1999 28' single diesel pilothouse fisherman

* The following is the list of Deficiencies, (not listed in priority order), that require correction.

B) Bow Thruster:

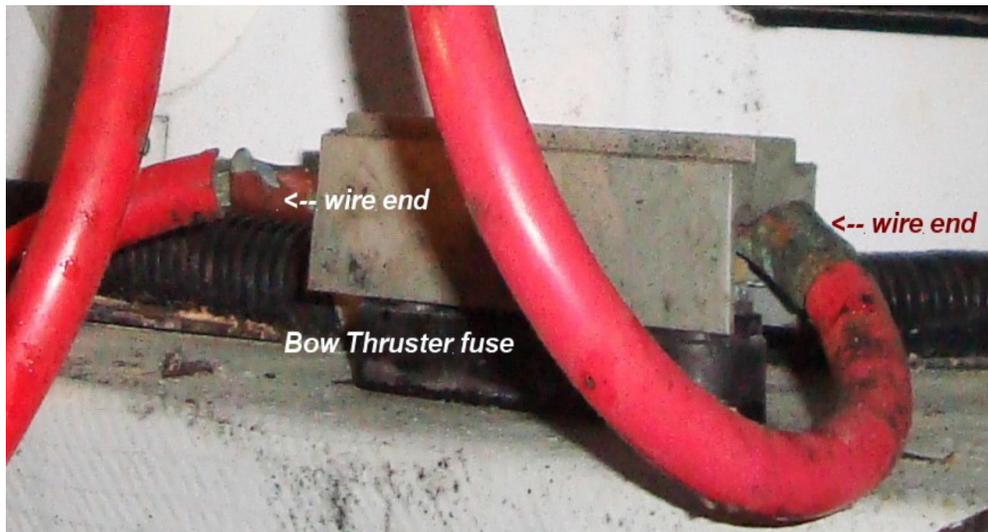
i) install cover on the 2- "+" lugs on the thruster DC motor. *(ABYC std. E-10.7.7)*

ii) install cover on the 2- bare metal terminal ends of the + wires at the high capacity in-line fuse (stbd. under cockpit deck fwd. hatch). *(ABYC std. E-10.7.7)*

iii) thruster powers on when the battery switch is in "OFF" position: If the thruster is powered by the 4D battery; a battery switch needs to be installed between that battery & the thruster.

ABYC std. E- 11.6.1.2.1- A battery switch shall be installed in the positive conductor(s) from each battery or battery bank with a CCA rating greater than 800 amperes or 100 Ah if CCA is unavailable.
